REMARKS

ANNOTATED MARKED-UP DRAWING - 1 OF 1

USSN 09/926,067

FIG. 1

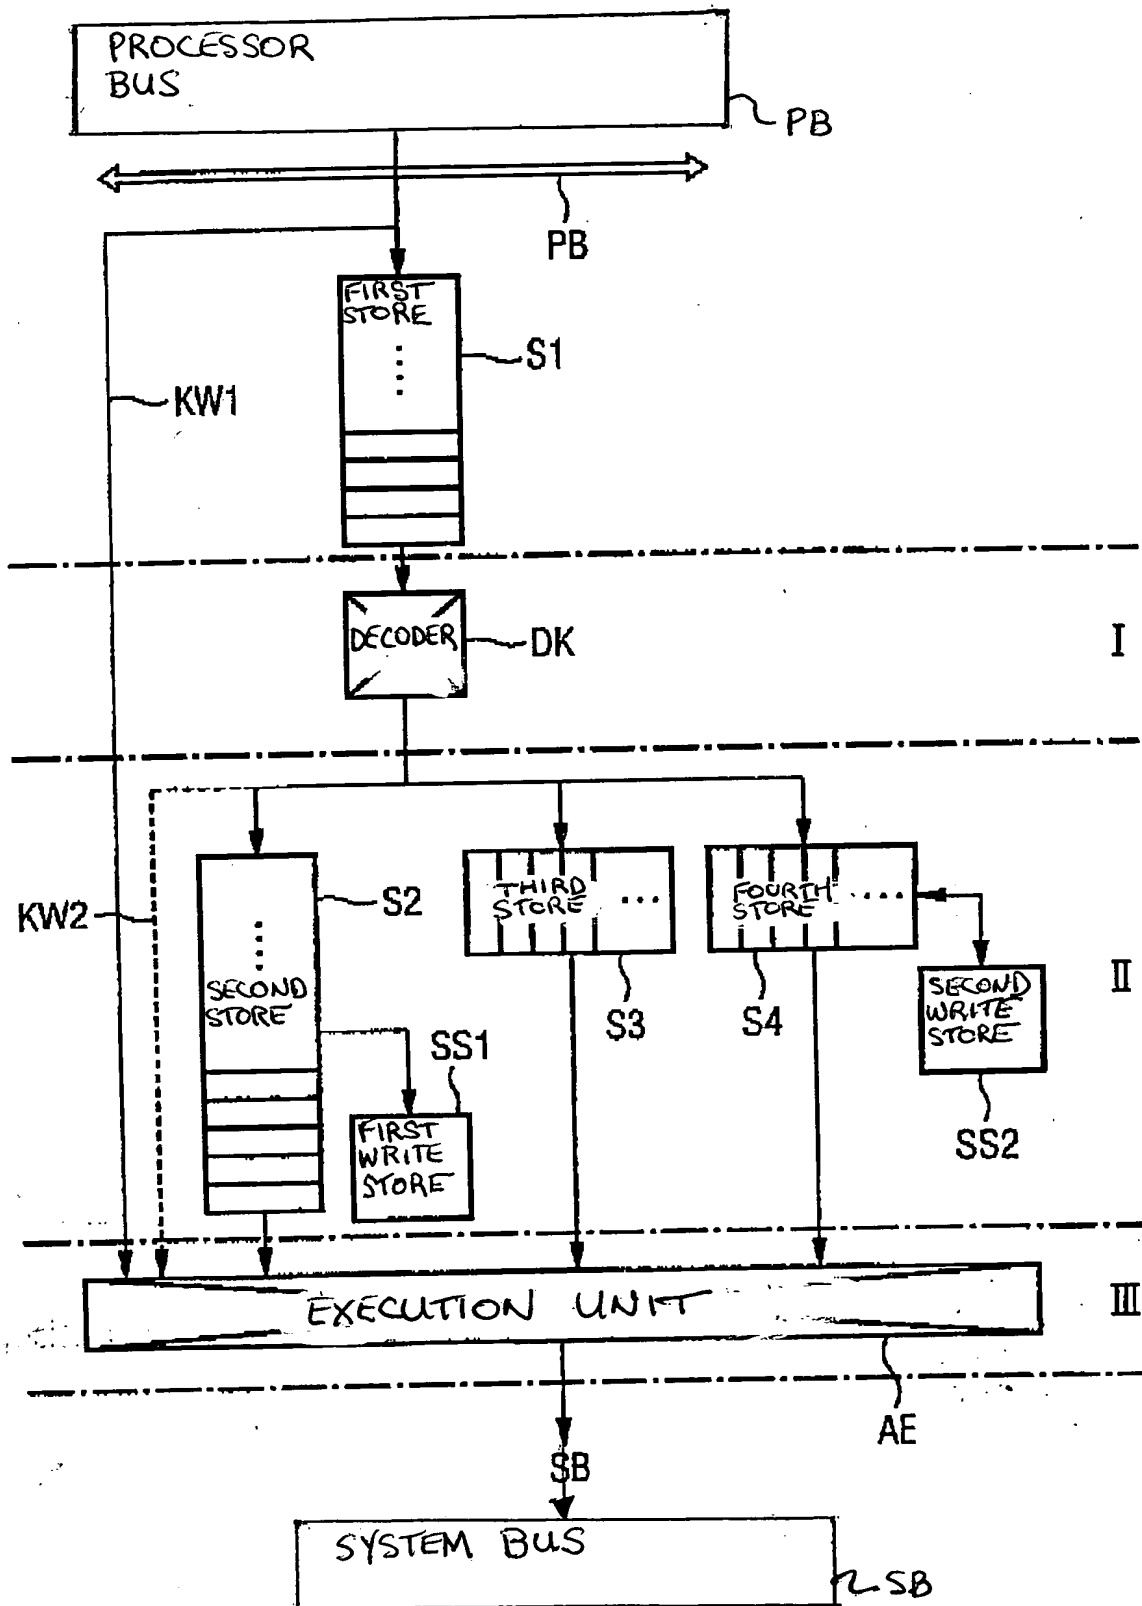
The Examiner objected to the drawing as lacking word labels which, if present, would facilitate an understanding of what each of the elements in the drawing represents. Accordingly, a corrected version of FIG. 1, labeled as "Replacement Sheet 1 of 1", is submitted herewith. An annotated marked-up drawing for sheet 1/1 is also enclosed herewith for the convenience of the Examiner, with additions indicated in red and deletions indicated in yellow. Word labels were added to identify processor bus (denoted as PB in the originally filed version of the drawing), first store (S1), second store (S2), third store (S3), fourth store (S4), decoder (DK), first write store (SS1), second write store (SS2), execution unit (AE), and system bus (SB). The aforementioned terms were used throughout applicant's originally filed disclosure to refer to corresponding elements of FIG. 1. Moreover, a label was added to Replacement Sheet 1 of 1, so as to identify this sheet as including FIG. 1. No new matter was added. Thus, it is submitted that the corrected version of FIG. 1 will facilitate the Examiner's understanding of the various drawing elements.
